**CALIFORNIA COASTAL COMMISSION**

March 24, 1998

**SUBJECT:** Proposed Major Amendment (2-97) to the University of California Santa Barbara Certified Long Range Development Plan for Public Hearing and Commission Action at the April 9, 1998, Commission Meeting in Long Beach.

FIGURE 1

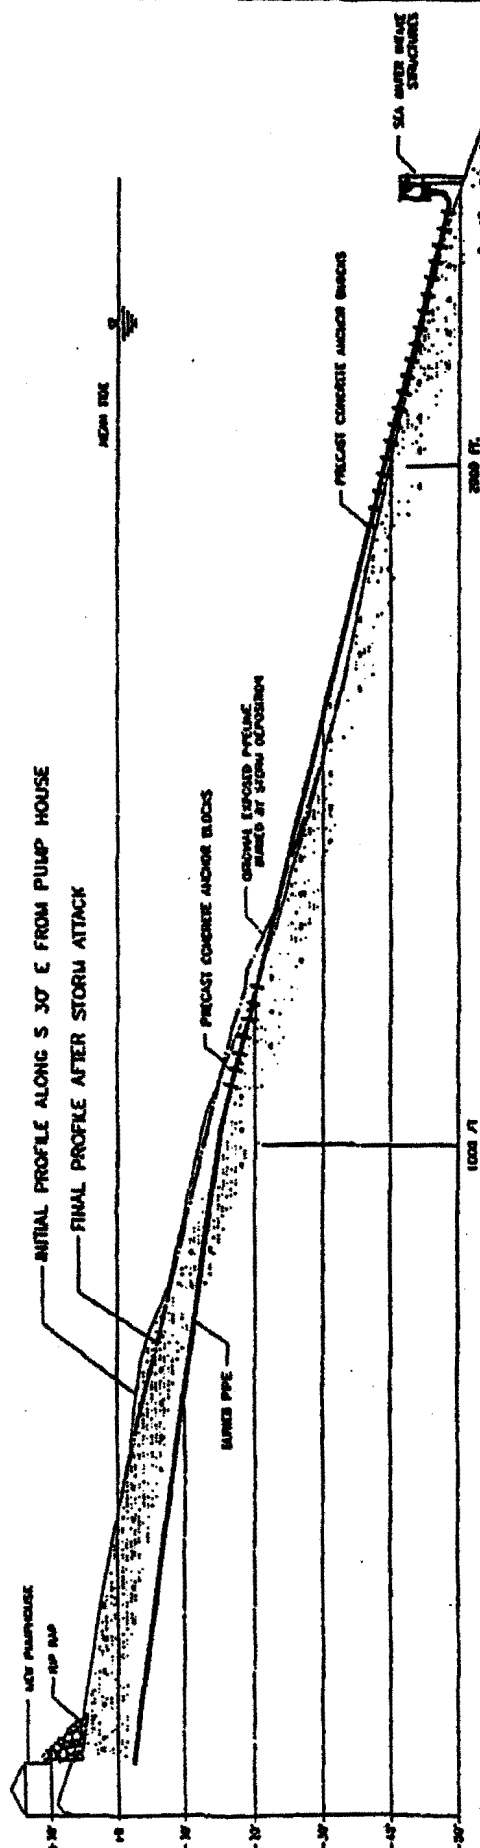
The result of the model simulation of the attack by W to WSW waves is presented as the final profile on Figure 1. It is clear that the most vigorous attack that can be postulated reasonably left the modeled wall intact. No scour was evident at the position of the wall. Only about 3 ft of erosion of sand occurred at the position of the plunge point of breaking waves (about -3 to -4 ft MSL). The sand eroded from the plunge point was distributed in a sheet extending to a depth of about -30 ft MSL. A slight bar formed at a depth of -20 ft MSL. Below a depth of -30 ft MSL, no change in the profile occurred.

FIGURE 2

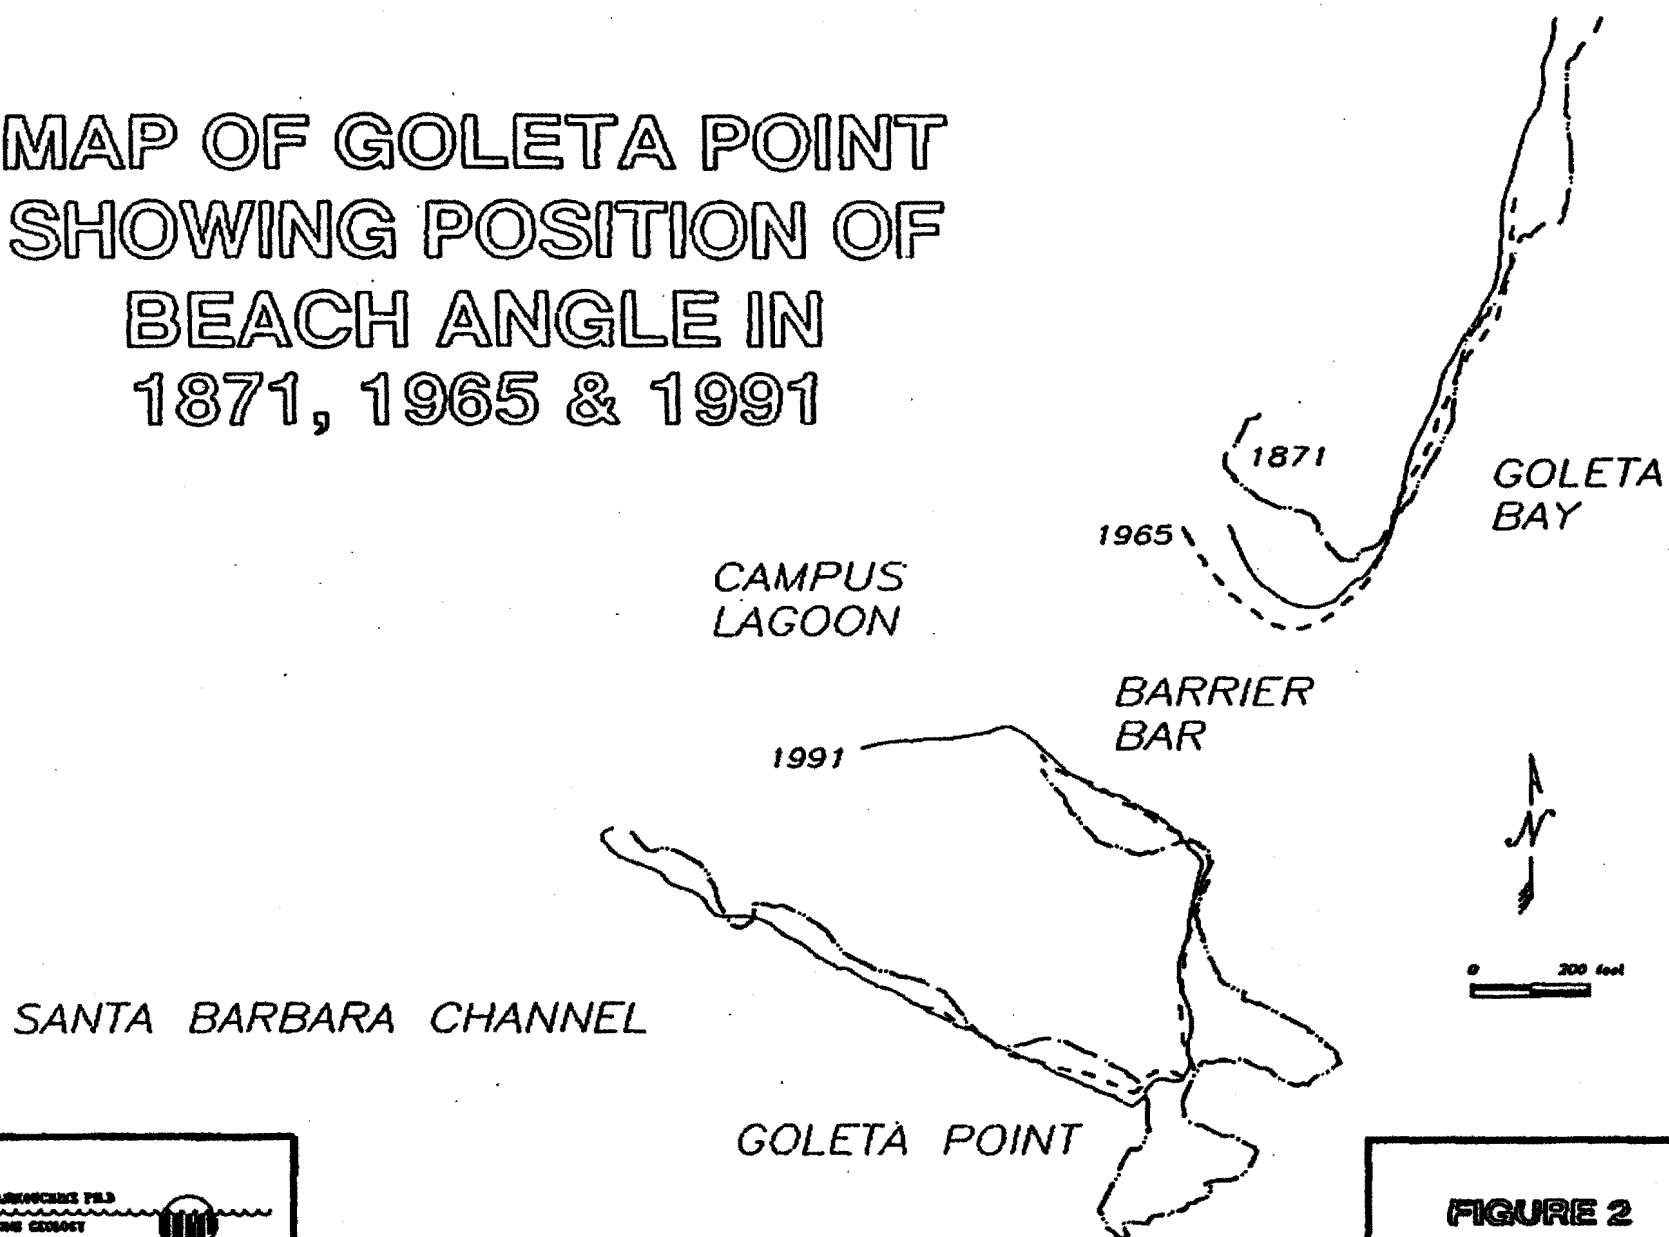
The shore angle (intersection of seacliff and beach) lines abstracted from each map are shown on Figure 2. These maps of the shore indicate that virtually no change in the position of the shoreline has taken place at the site during the interval from 1871 to the present. This can be attributed to the protected location of the site and to the presence of claystone in the seacliffs at Goleta Point and along Goleta Bay.

A model study of changes in the the planiform of Goleta Bay under conditions of sediment influx from the mouth of the Goleta Slough indicated that, under the influence of the typical regime of waves in the Santa Barbara Channel, most of the introduced sediment was transported to the lee of Goleta Point. This would imply that long-term erosion of the beach at the subject site is improbable.
